What replaced Integral 18 and 32 DOL reversing starters – LD5, LB1 and LB6?

Integral Replaced by Tesys U

FA141941 | 3.0 | Published date: 13-Feb-2012

Integral 18 and 32 reversing DOL (old model)	Tesys U reversing LU2B (new model)

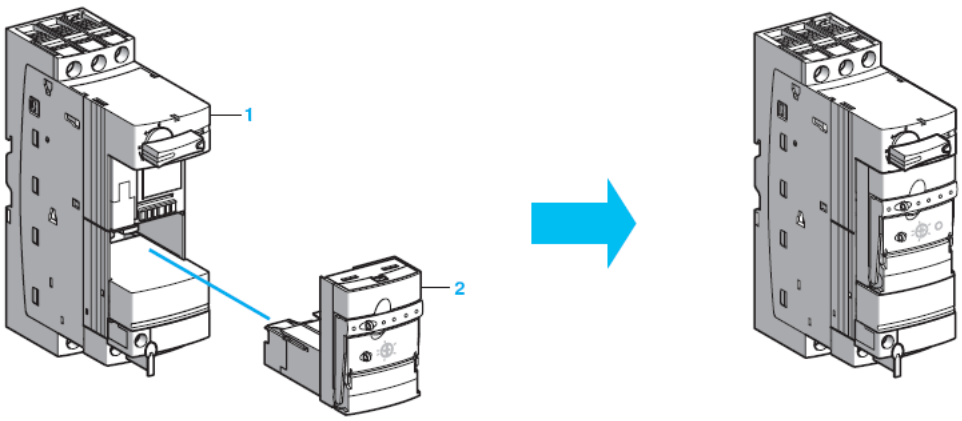
The Integral 18 and 32 series starters have been discontinued. They have been replaced by the Tesys U series.

Tesys U - employs different, more modern and efficient structures and technology, therefore there is no compatibility or interchangeability between any of the parts. This means that to replace any part of the Integral starter will require changing the complete unit for a Tesys U. As there are no directly equivalent

To replace the simple motor starter aspect is easy. A basic Tesys U Motor Starter comprises only 2 parts, the base unit (1) (which contains the reversing contactor, rated at up to 12A or 32A (LU2B12 or LU2B32 respectively) and a Control unit (2), which determines both the control voltage and the overload current range.
